This manuscript has been previously reviewed at another journal. This document only contains reviewer comments and rebuttal letters for versions considered at Communications Physics

Reviewers' comments:

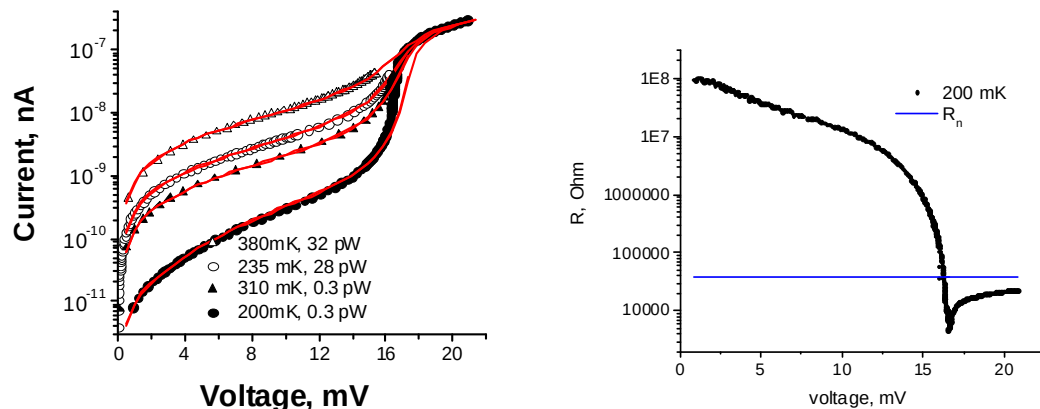
15. Line 226-230: figure 3-A. When determining the sample parameters, how was the asymptotical resistance (R in reference [8]) defined? Where the measurements extended to the asymptotic range?

We add a figure with differential resistance on voltage in Supplementary materials and a description of the measurements of the normal state resistance.

R_n is measured above the critical temperature of aluminum. Also it can be measured below the critical temperature, but it requires voltages 3-4 times higher than the gap, because the IV-curve approaches the asymptotic line $V = I * R_n$ very slowly. This is shown in the figures below.
